**RE: Tucson South Resource, M-2004-044, Amendment Number 1 (AM01)
Adequacy Review No. 2**

Enclosure: *Memorandum, Adequacy Review of Exhibit 6.5 – Geotechnical Stability Adequacy Response
Aggregate Industries; Tucson South Resource; File No. M-2004-044; AM0, Dated July 25, 2019*

**Re: Adequacy Review of Exhibit 6.5 – Geotechnical Stability Adequacy Response
Aggregate Industries; Tucson South Resource; File No. M-2004-044; AM-01**

Project Tucson South AM
C-1 - Static

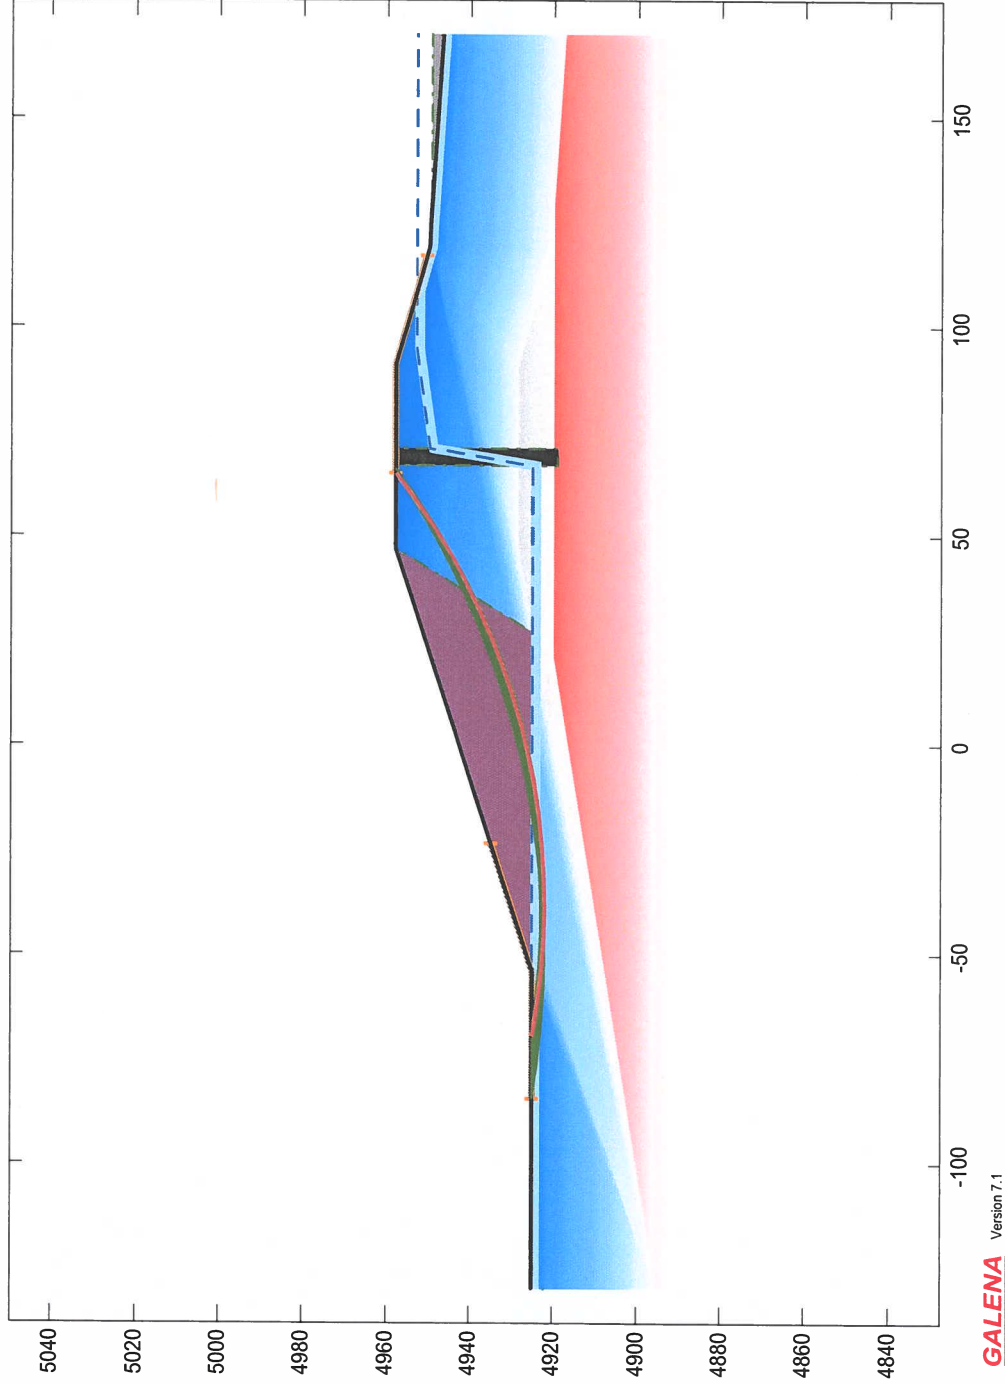
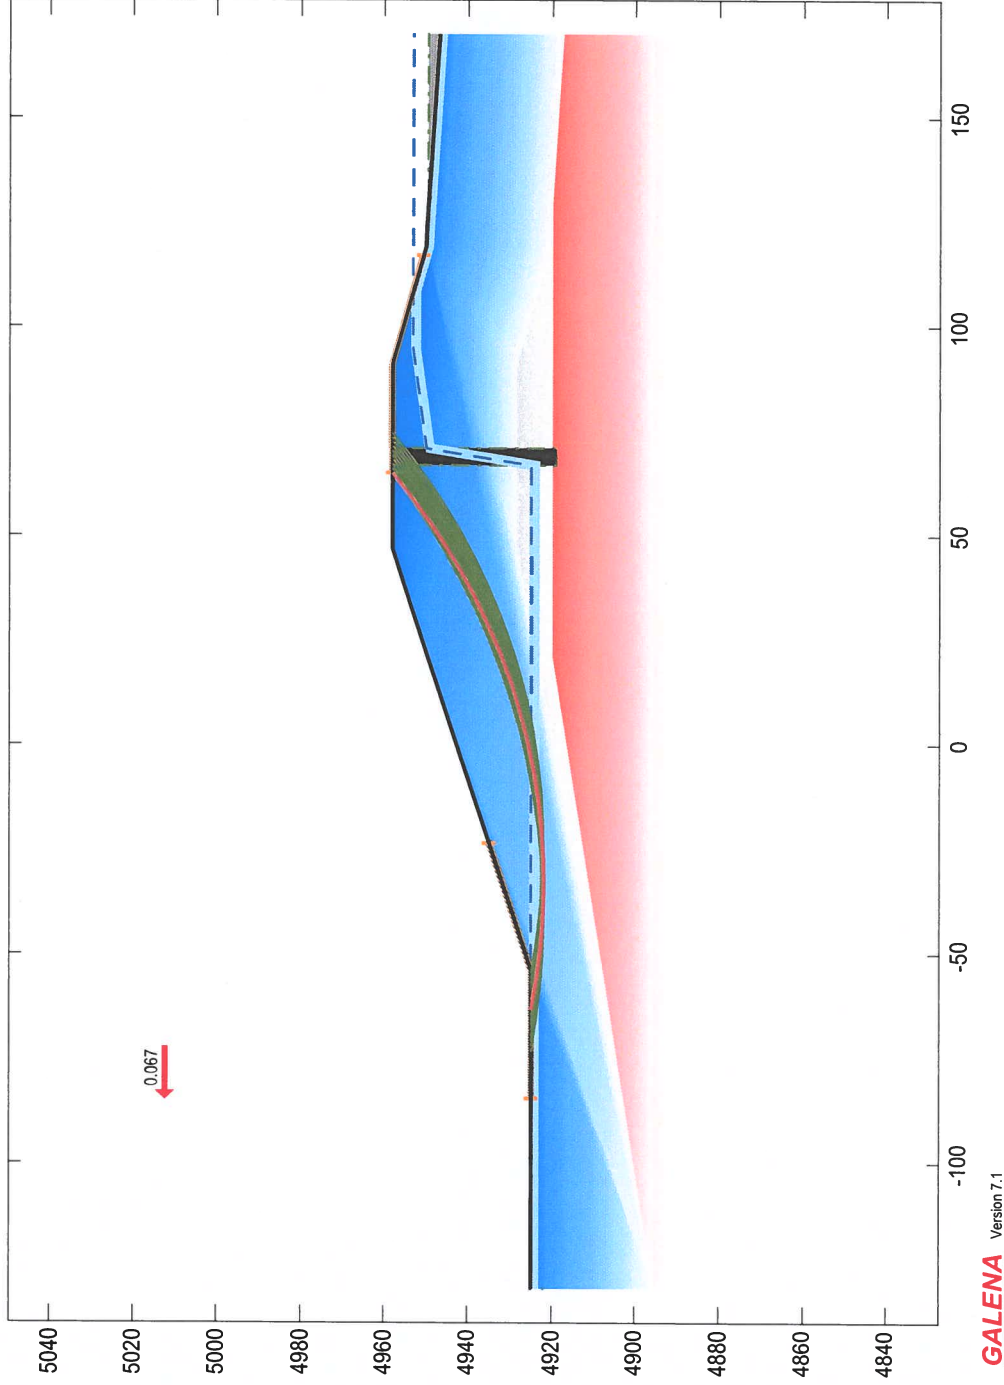
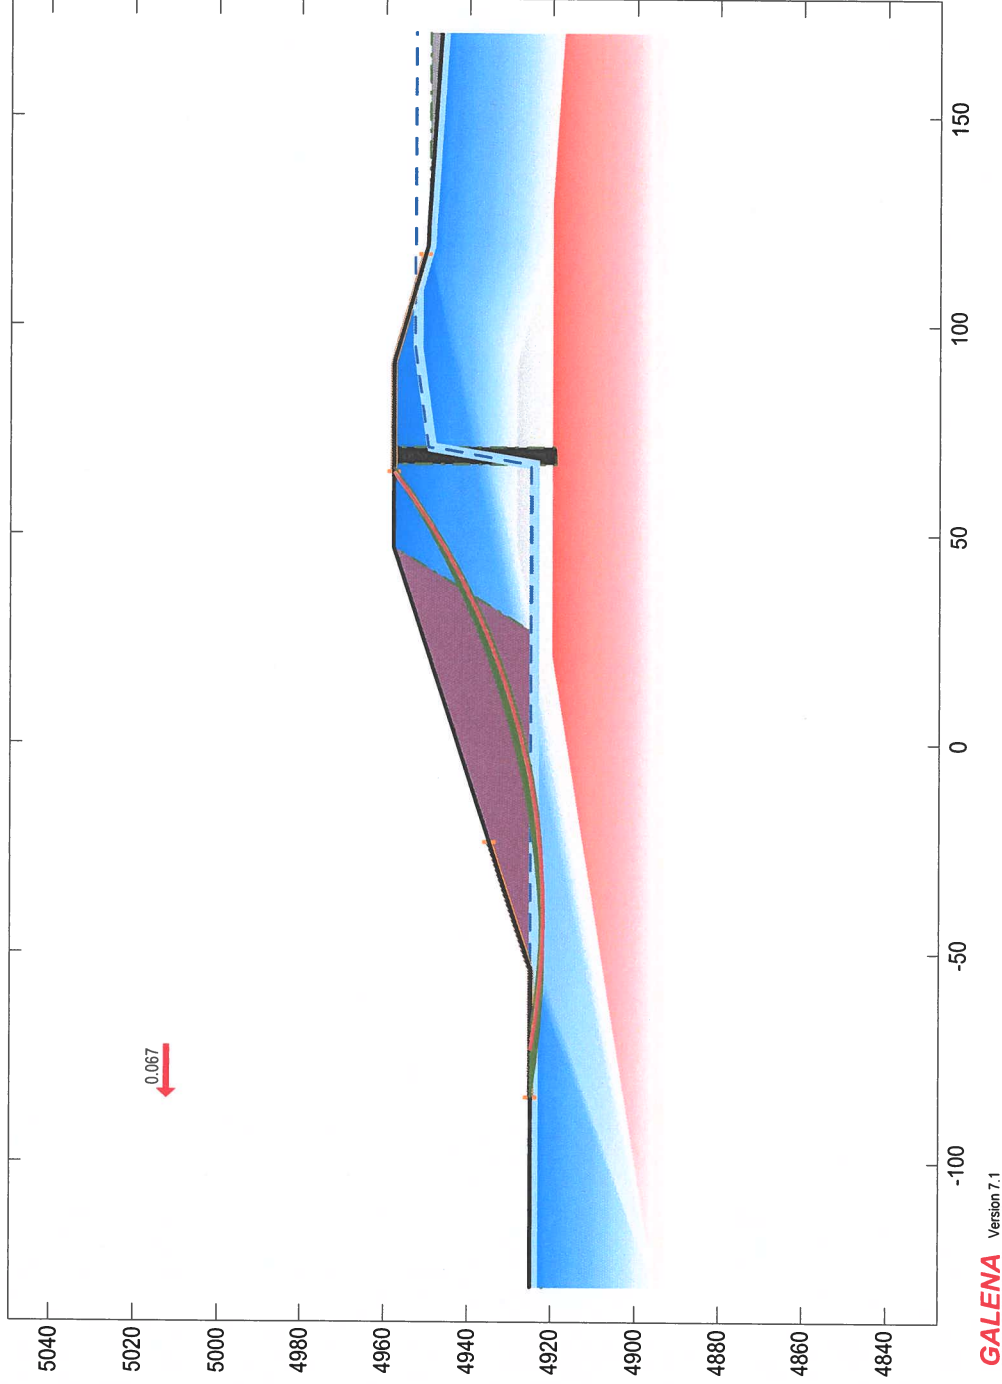
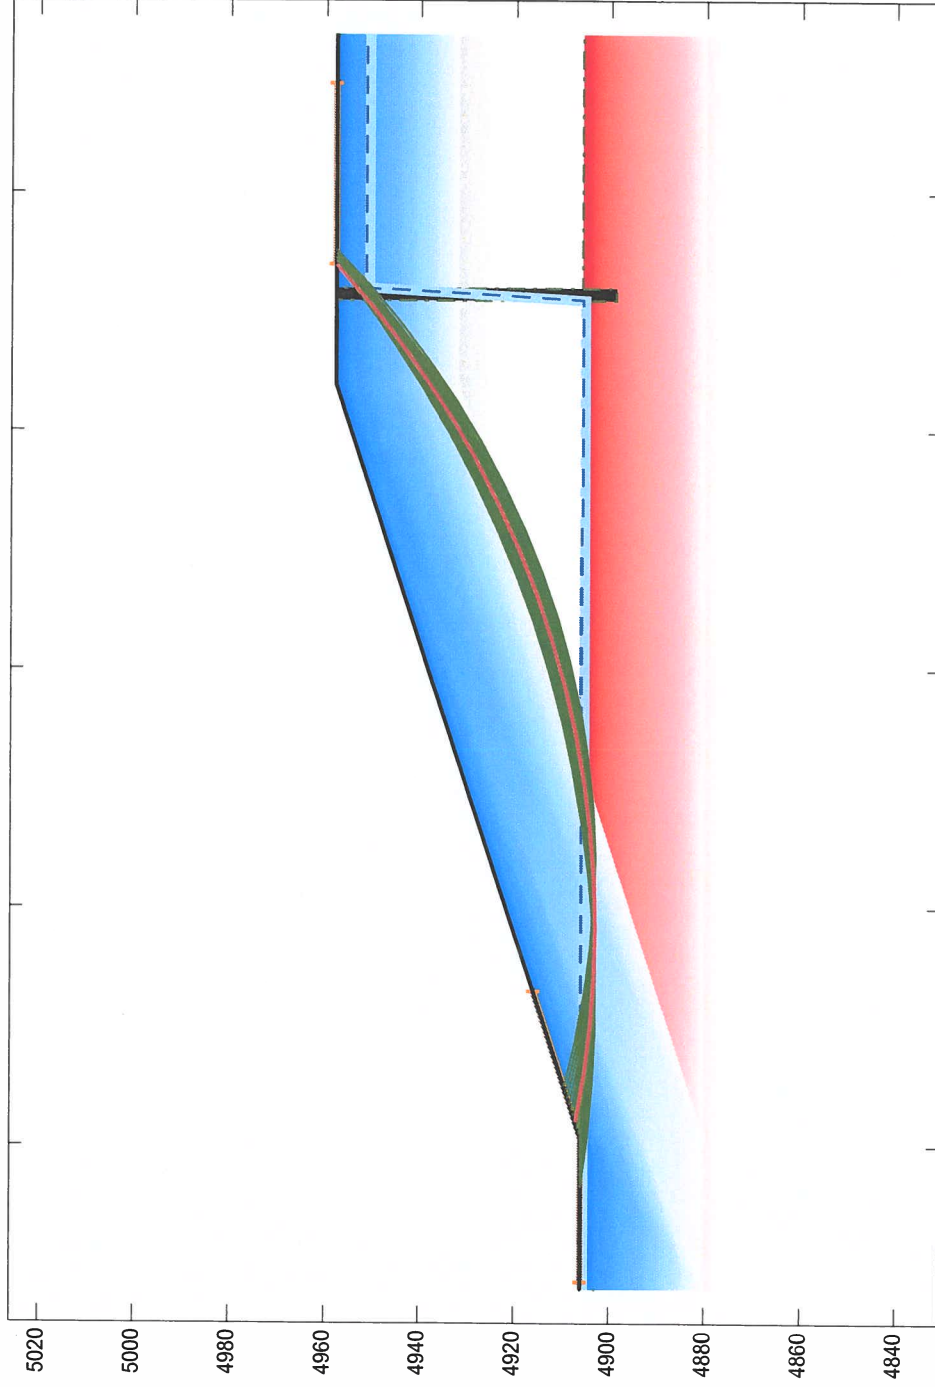
1. The Applicant modeled the Figure C analysis with a 44 feet offset from the top of bank (tob) of the South Platte River to the top of the mine slope. The Exhibit C-3 Map indicates the Applicant modeled a 42 feet offset. Please explain this discrepancy and revise the Figure C models and/or the Exhibit C-3 Map accordingly.

Project Tucson South AM
D-1 - Static

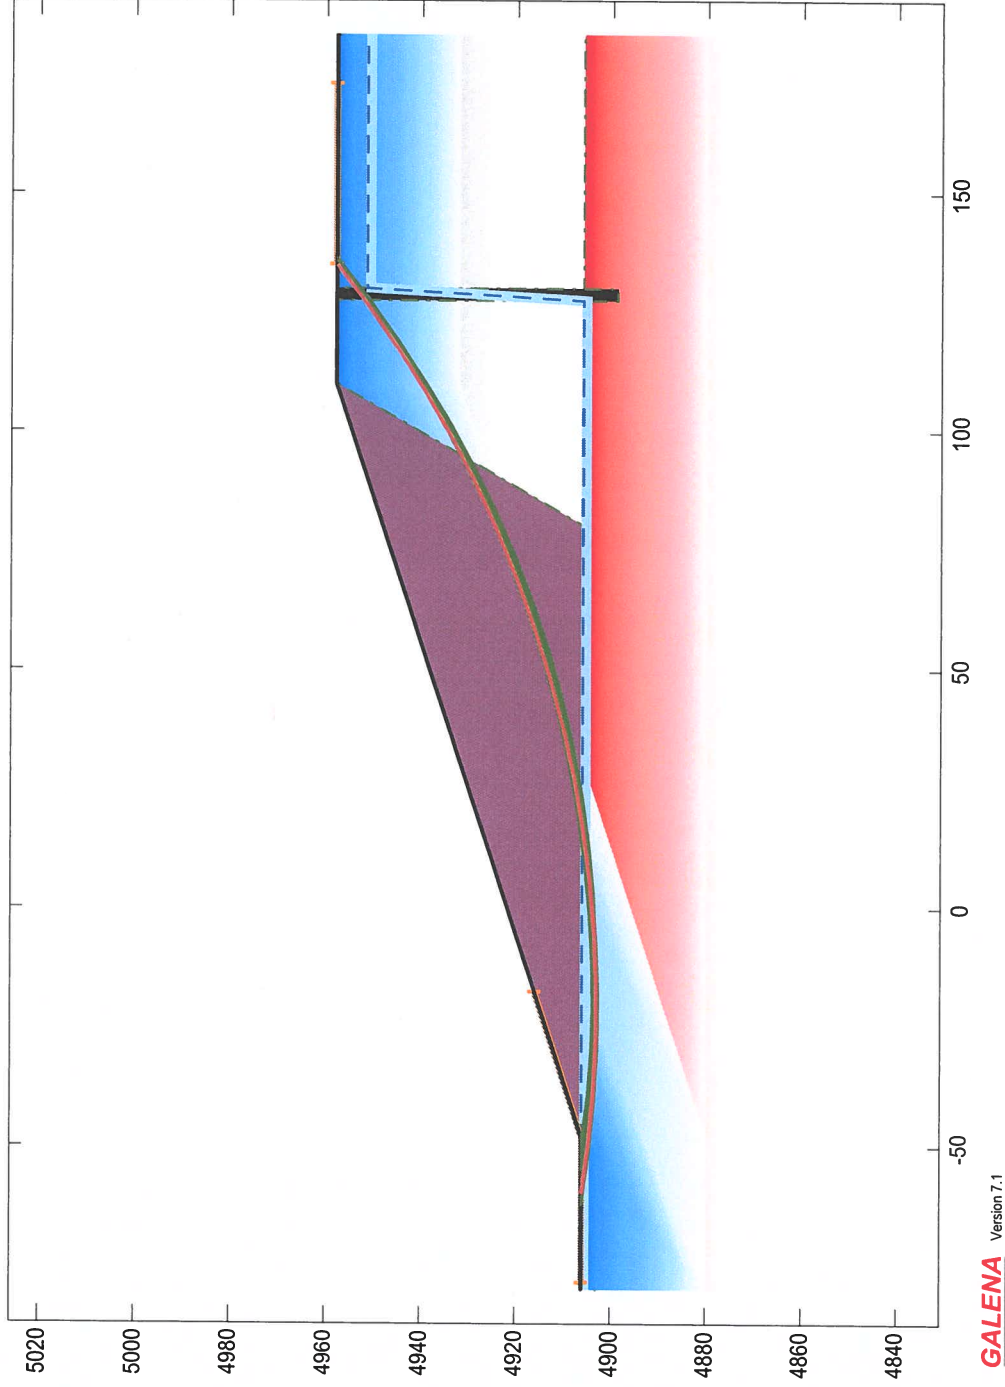
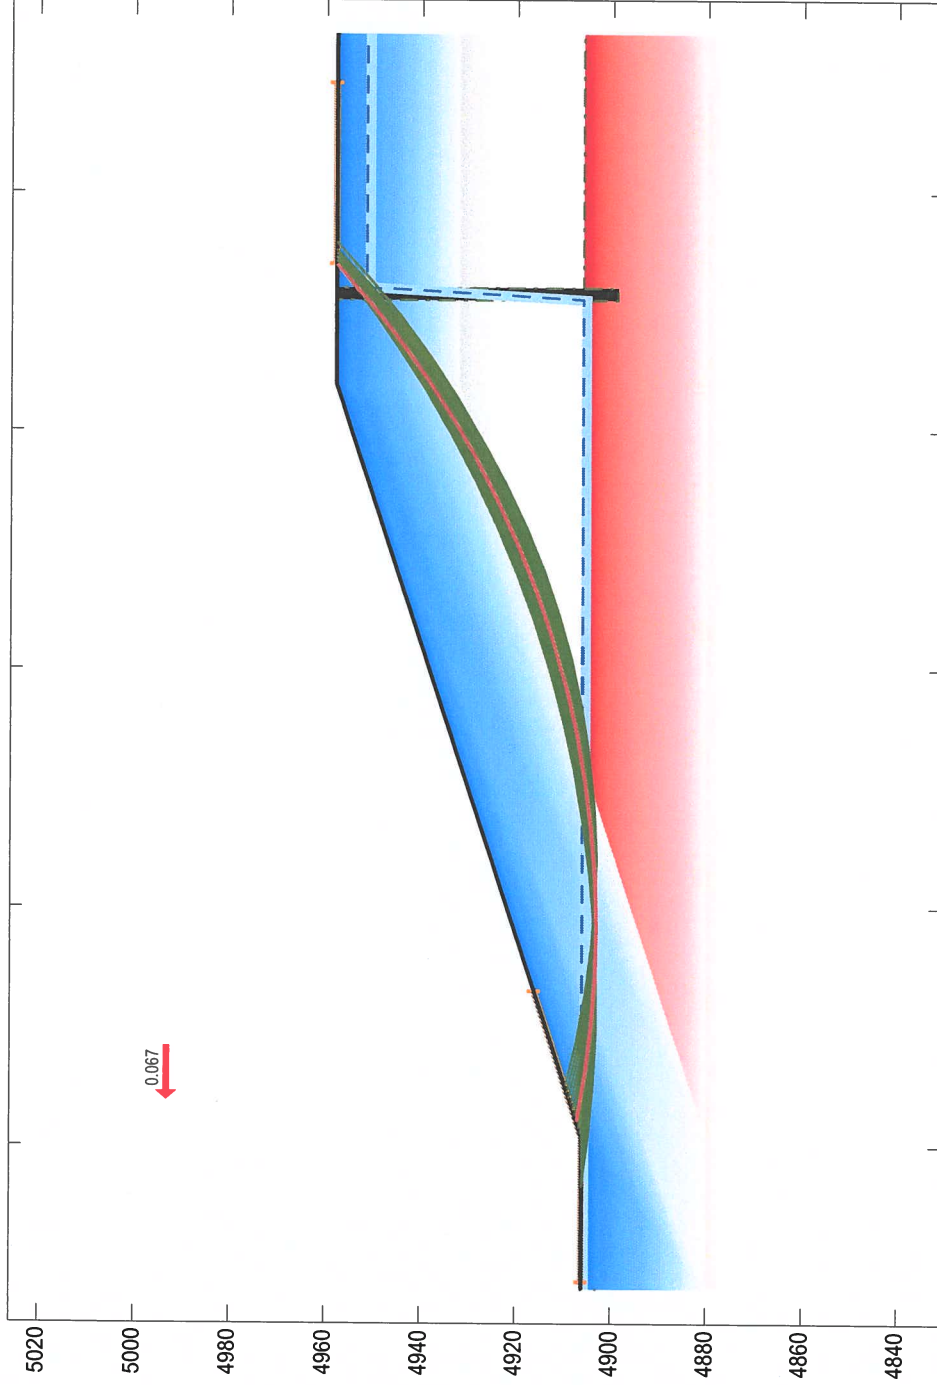
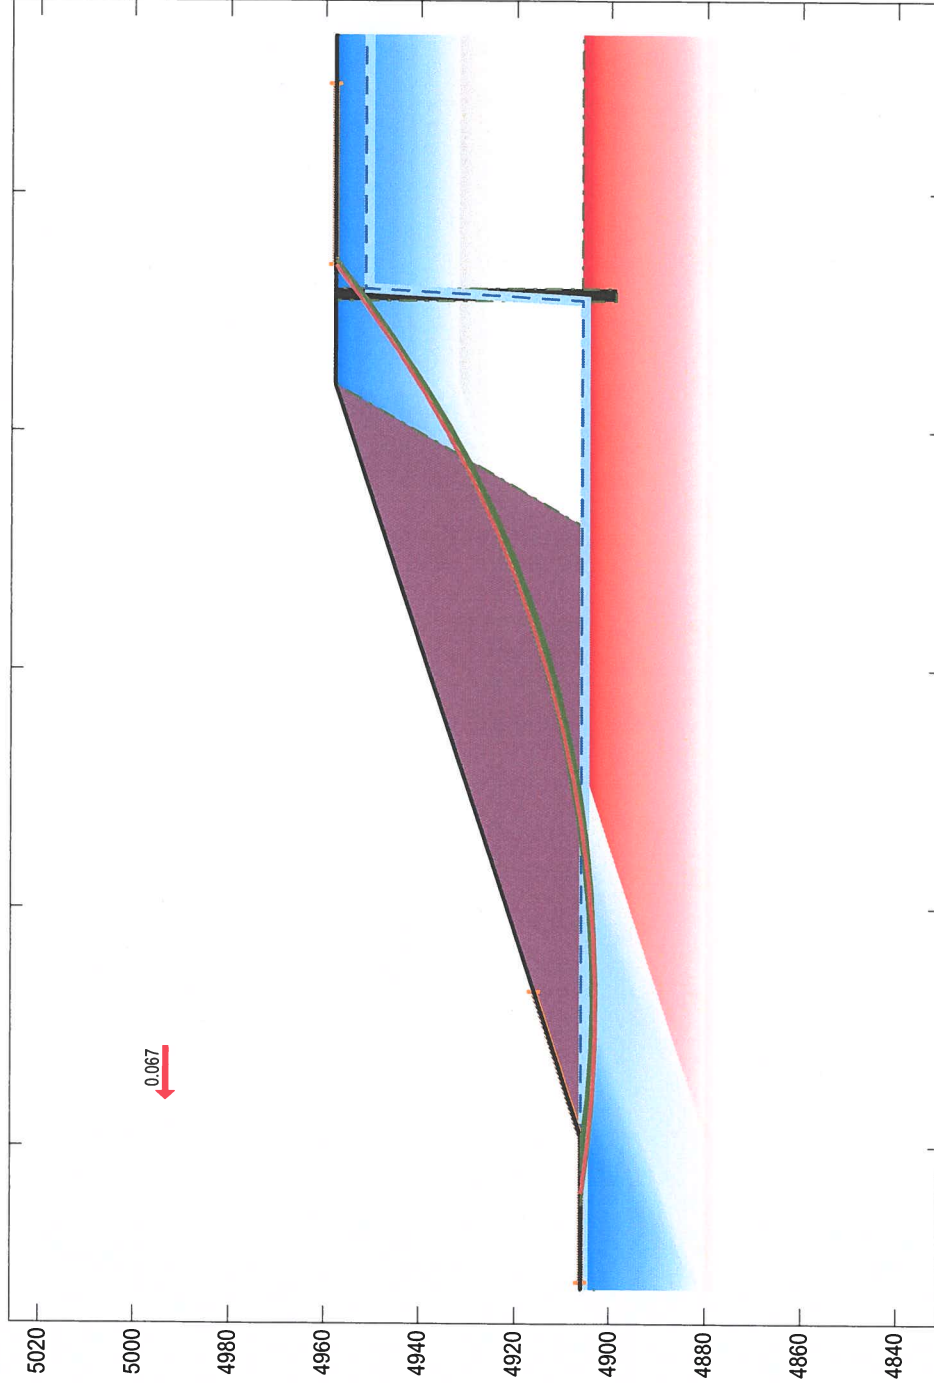
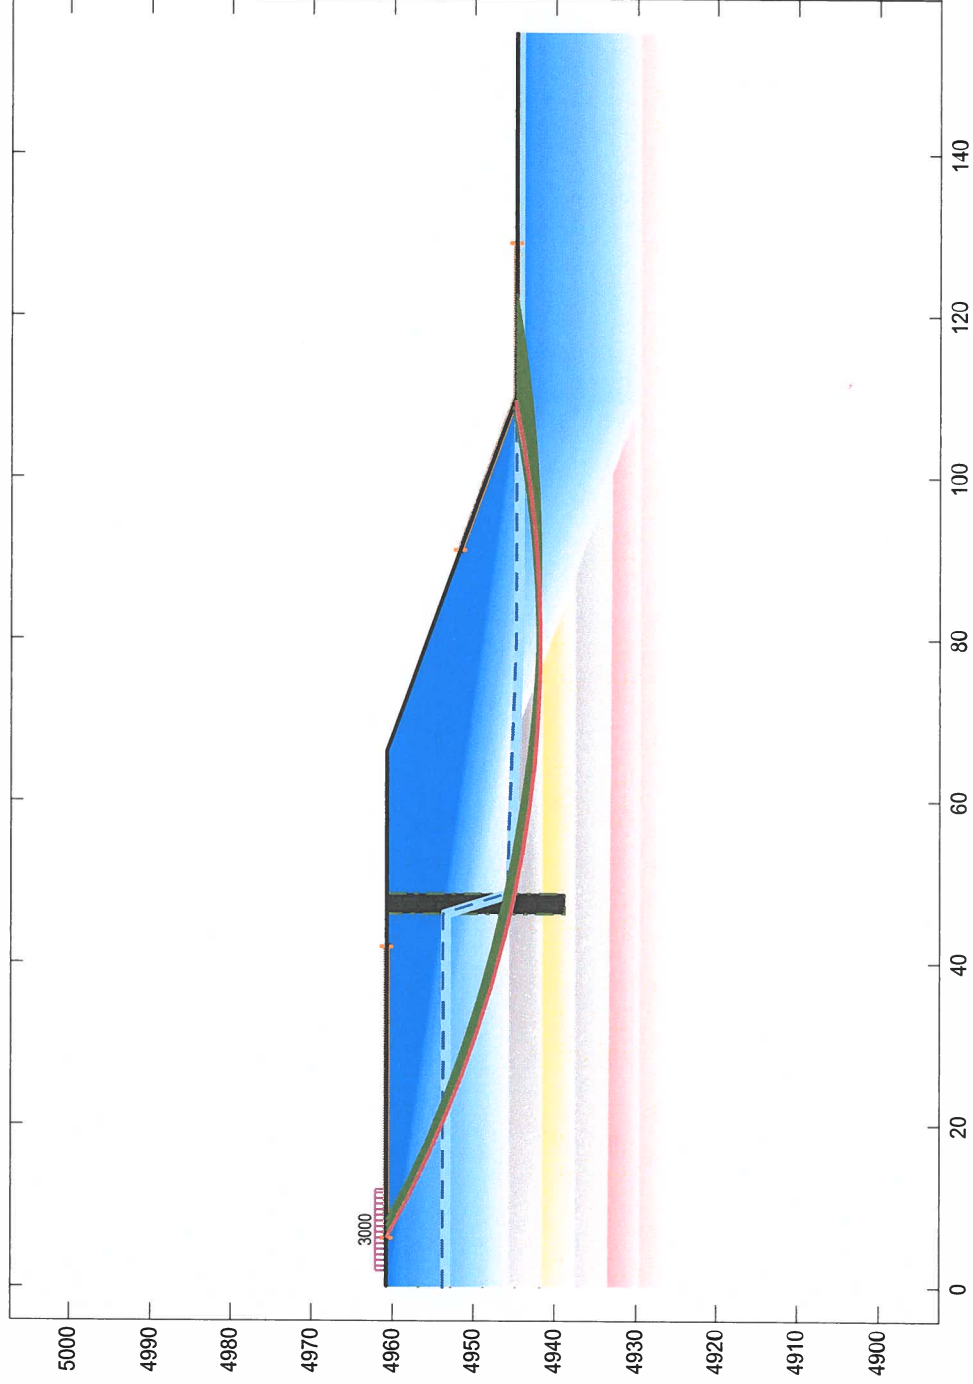
2. The Applicant modeled the Figure D analysis with a 35 feet offset from the pipeline easement to the top of the mine slope. The Exhibit C-3 Map indicates the Applicant modeled a 45 feet offset. Please explain this discrepancy and revise the Figure D models and/or the Exhibit C-3 Map accordingly.
